ADDENDUM FIVE

Solicitation Number: 2024-023
Solicitation Name: New Construction, Cherokee County EMS Station #30
Addendum Release Date: April 15, 2024

ADDITIONS & RENOVATIONS TO: CHEROKEE COUNTY EMS STATION #30

**SHEET C4 UTILITY PLAN
ADDENDUM #5
FDC CLARIFICATION
04/15/24**

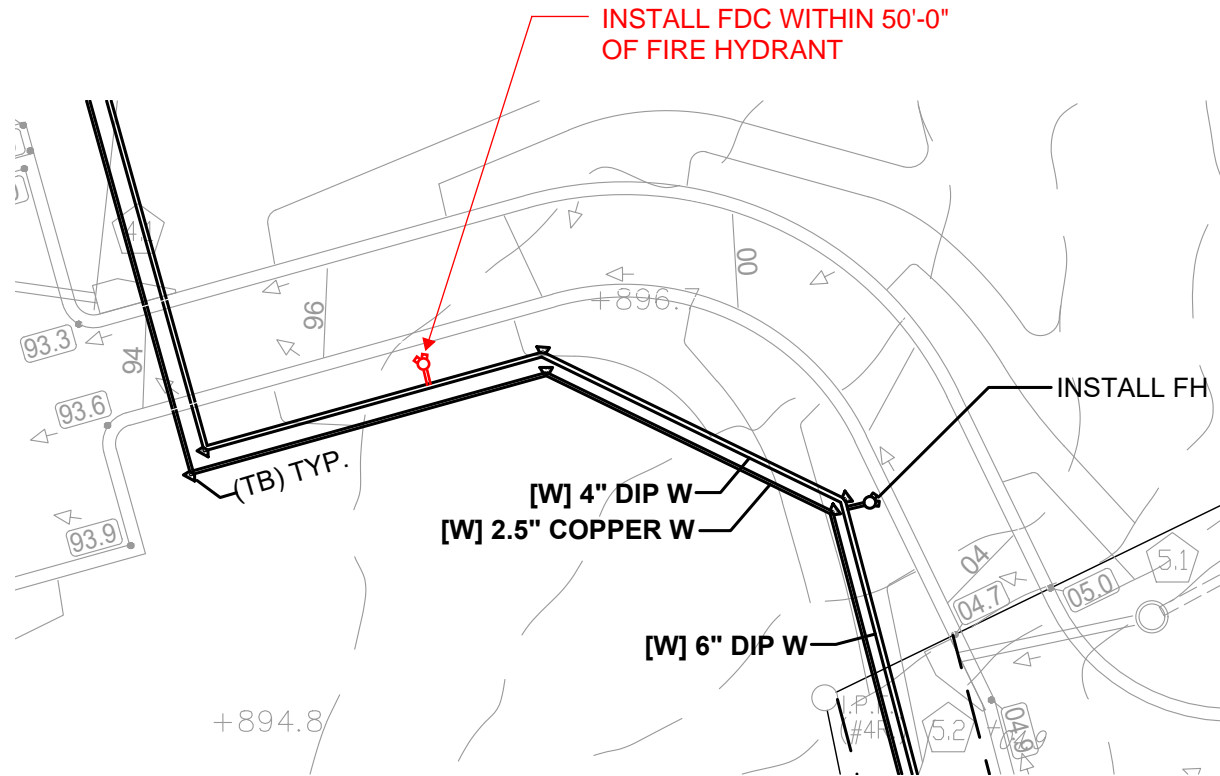
Civil Clarification

See attached sketch clarifying intended FDC placement (see attachments).
